APPLICATION FOR PERMISSION UNDER SECTION 16 OF THE TOWN PLANNING ORDINANCE (CAP.131)

For Official Use Only 請勿填寫此欄	Application No. 申請編號	A/NE-HLH/51
	Date Received 收到日期	- 2 MAR 2021

(a) Proposed use(s)/development 擬議用途/發展	Proposed Temporary Warehouse and Open Storage of Construction Machinery & Construction Material for a Period of 3 Years (Please illustrate the details of the proposal on a layout plan) (請用平面圖說明擬議詳情)

Application No. 申請編號	(For Official Use Only) (請勿填寫此欄)
Location/address 位置/地址	Lots 171 (Part), 172 (Part), 176 (Part) & 177 (Part) in D.D. 87, Ta Kwu Ling, New Territories
Site area 地盤面積	6,936 sq. m 平方米 <input checked="" type="checkbox"/> About 約 (includes Government land of 包括政府土地 Nil sq. m 平方米 <input type="checkbox"/> About 約)
Plan 圖則	Approved Hung Lung Hang Outline Zoning Plan No. S/NE-HLH/11
Zoning 地帶	'Agriculture' ("AGR")
Type of Application 申請類別	<input checked="" type="checkbox"/> Temporary Use/Development in Rural Areas for a Period of 位於鄉郊地區的臨時用途/發展為期 <input checked="" type="checkbox"/> Year(s) 年 <u>3</u> <input type="checkbox"/> Month(s) 月 _____ <input type="checkbox"/> Renewal of Planning Approval for Temporary Use/Development in Rural Areas for a Period of 位

Proposed Layout Plan

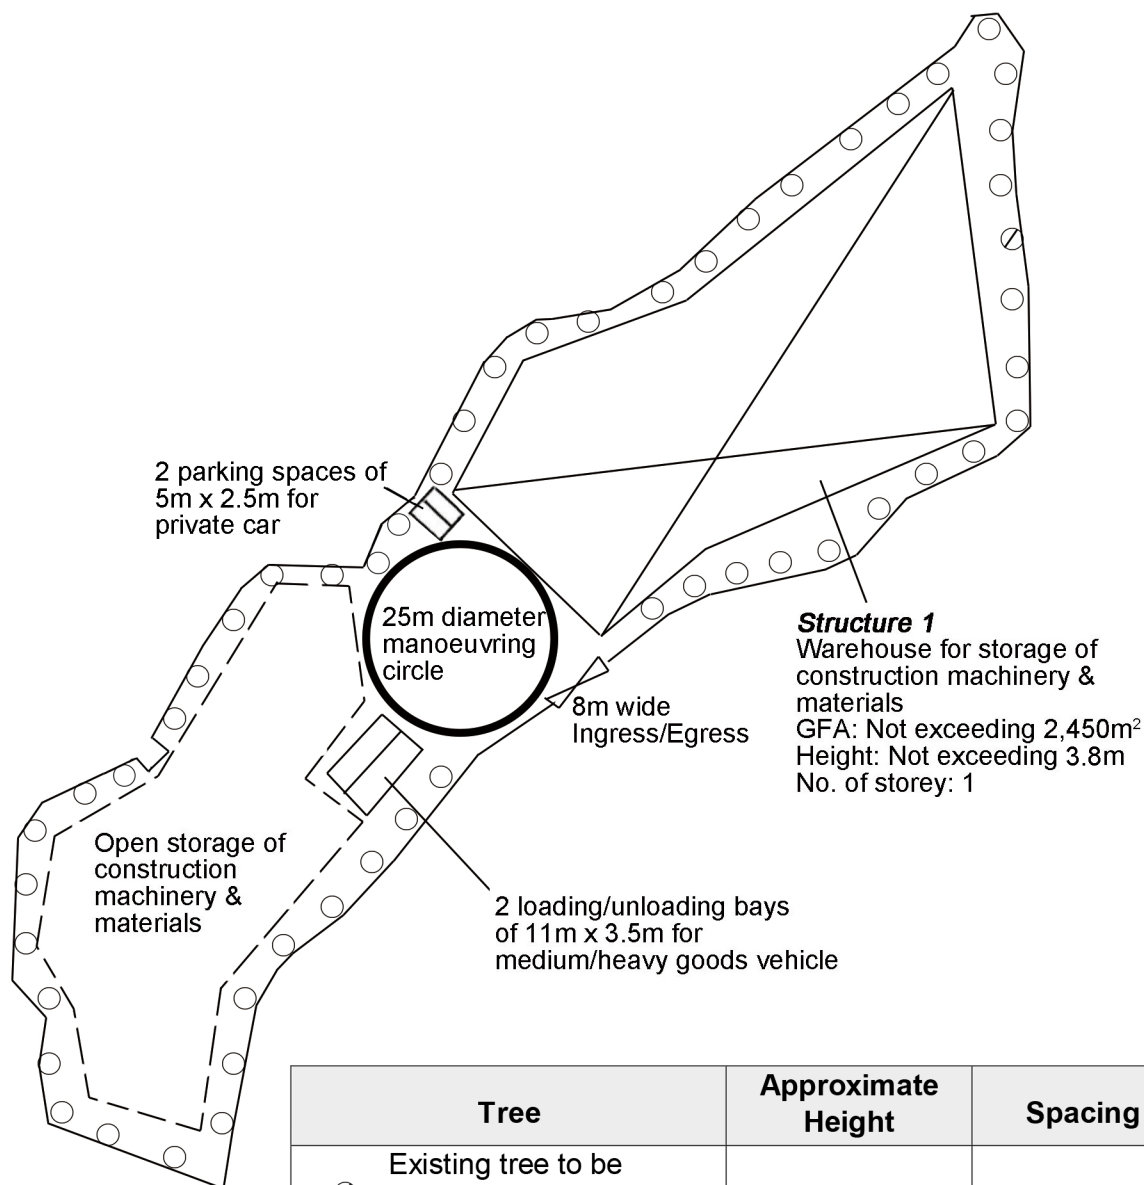
to the proposed development.
(c) The Applicant should state whether the warehouse has any opening (including windows and doors). If positive, their location, which should be oriented away from nearby residential buildings, should be indicated on a figure for our consideration;	The opening of the warehouse is facing south as shown in updated Figure 3 and there is no window for the proposed warehouse. It is not directly facing the domestic structure which is situated to the west of the application site.

The opening of the warehouse is facing south as shown in Figure 3 and there is no window for the proposed warehouse. It is not directly facing the domestic structure which is situated to the west of the application site.
